TECHNICAL INFORMATION

LAND-ROVER

'E' Post Trim Area - Water Ingress

Discovery

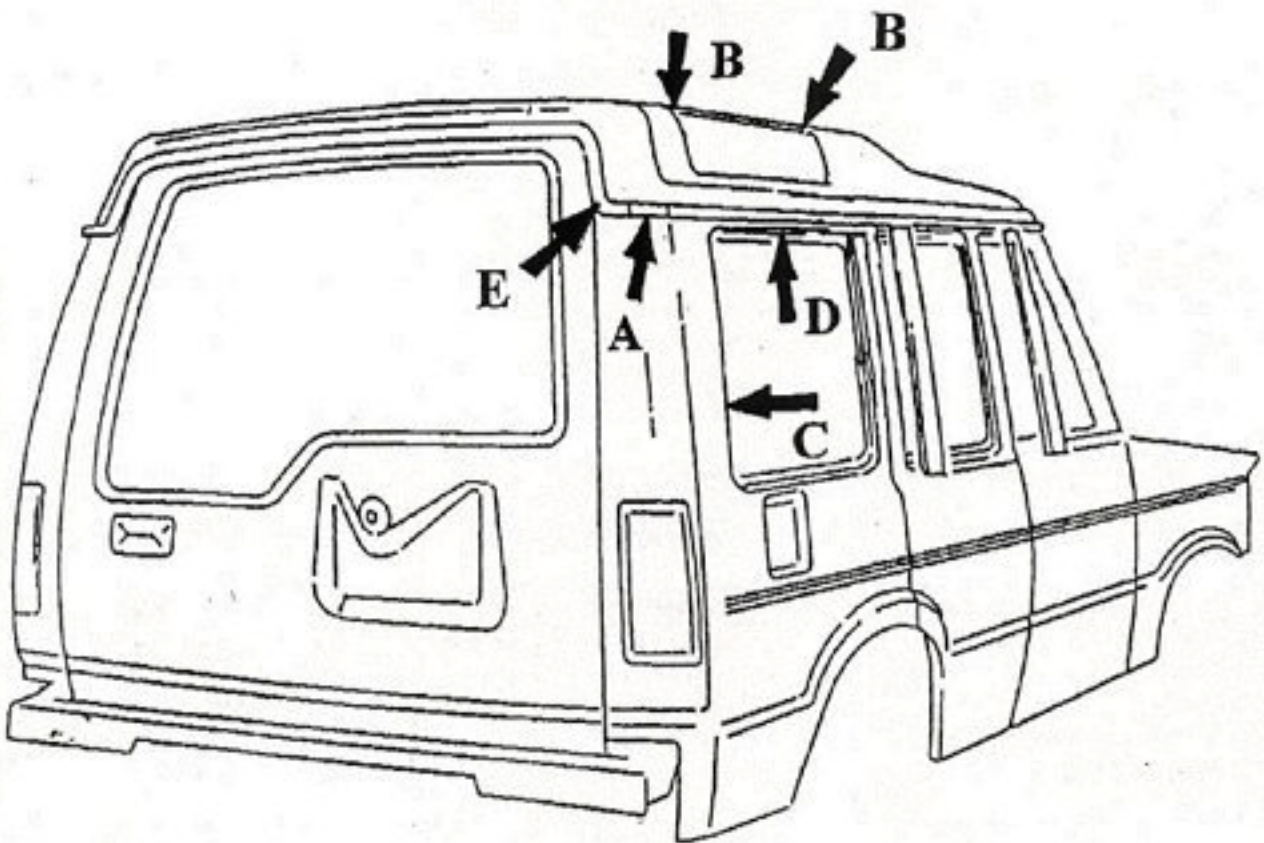
Water drips from alpine light
(see illustration, arrow B)

Check fixed glass sealing and reseal as
necessary (see illustration arrow C)

Check for cracks around flange see 'E' on
illustration, reseal each side of flange.
The flange has been moved inside can't
rail to improve water ingress concerns from
Vins 199607 and 530346

Inspect Zinc tape for pin holes and reseal as necessary
(see illustration arrow A)

Inspect cantrail to bodyside joint for pin holes and reseal as necessary
(see illustration arrow D)

1.

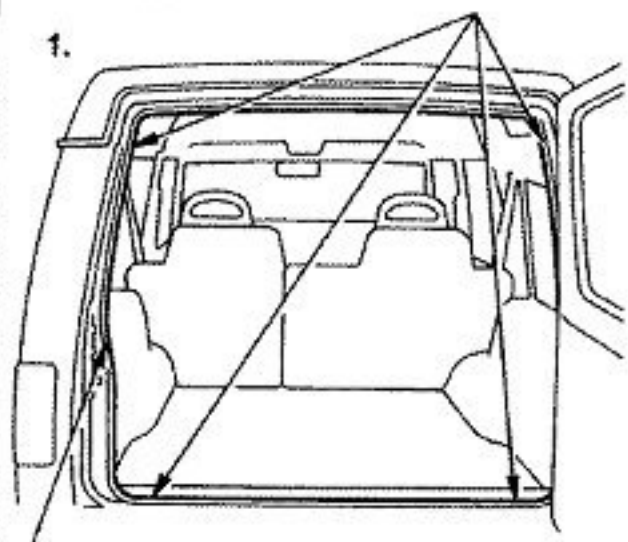
As part of ongoing quality improvements a new double bubble seal has been introduced onto the rear tail door. Early indications have identified a potential water leak from this area due to seals fitting incorrectly on a misformed seal flange. Investigations by Land Rover engineers have found that following procedure overcomes this issue on all vehicles.

1. Remove rear end door tread strip.
2. Remove rear end door seal from failed vehicle.
3. Using a craft knife, cut any excess trim tape that has been wrapped around the rear end door aperture see illustration 3.
4. Dress any flanges that appear to have panel mismatch to obtain a tight finish see illustration 1&2.
5. Smooth in Butyl around the four areas where the panel meets and form a channel to obtain a smooth finish for the foam tape see illustration 1&2.
6. Carefully apply the foam tape around the aperture as close as possible to the edge of the panel. Remove backing paper, smooth out, avoid any creases see illustration 1.

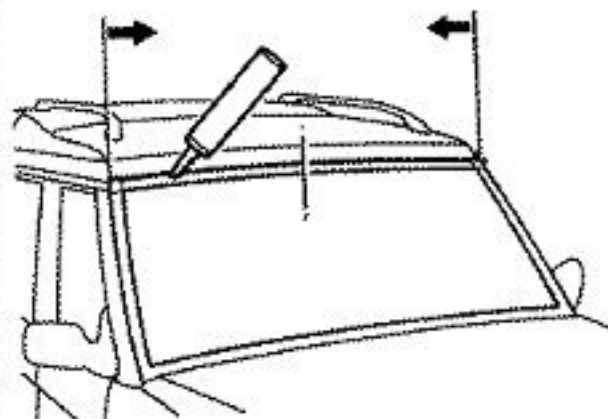
To overcome water ingress through the upper section of the windscreen seal a process has been developed to introduce a supplementary sealing operation behind the seal. Should a vehicle exhibit water ingress from this area follow the procedure below.

Locate sealant nozzle between top windscreen rubber and roof panel, extrude bead of sealant (continuous) from the centre of the vehicle towards the corners (see illustration opposite).

MODIFIED GUIDE TUBE (ILLUSTRATION A)

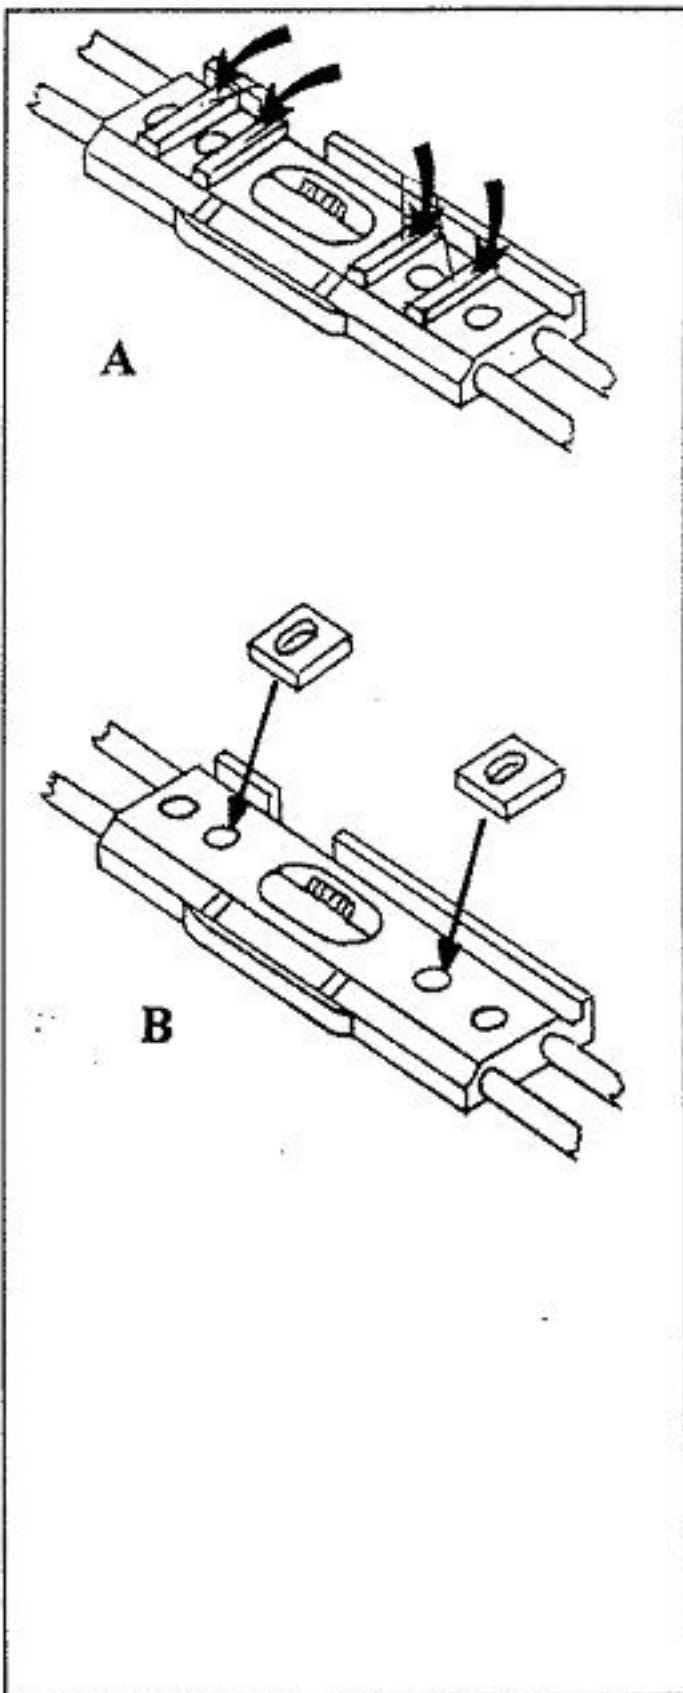
Following recent improvements to the sunroof lower tray STC 1686 and the guide tube assembly STC 1683, a spacer kit Part No STC 3194 (containing 4 white spacers) will be required if either the sunroof lower tray or the guide tube assembly are changed in vehicles prior to the Vins given.

When fitting a modified lower tray to an unmodified guide tube x 2 spacers must be fitted to the guide tube.

Gently lift the guide tube assembly off the two locating pegs on the upper frame to gain enough clearance to insert the spacers over the two inboard holes as indicated then reseal the guide tube assembly.

MODIFIED LOWER TRAY ILLUSTRATION 'C'

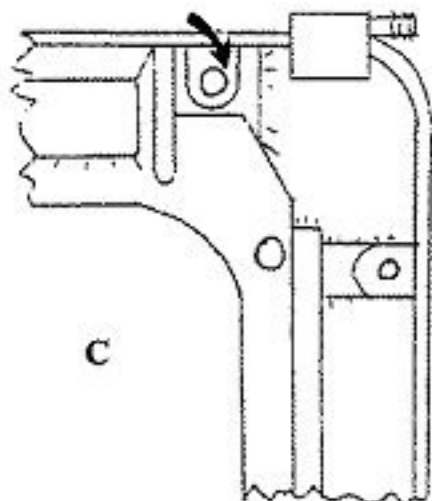
Underside view look for 'U' shaped impression around corner hole as shown opposite.

ILLUSTRATION 'E'

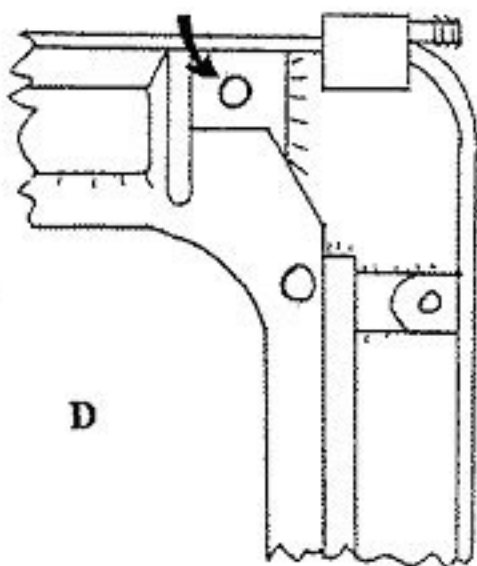
Fit x 4 spacers as indicated opposite to the inside of the lower tray.

When fitting a modified guide tube assembly to an unmodified lower tray x 4 spacers must be fitted to the inside of the lower tray as indicated opposite.
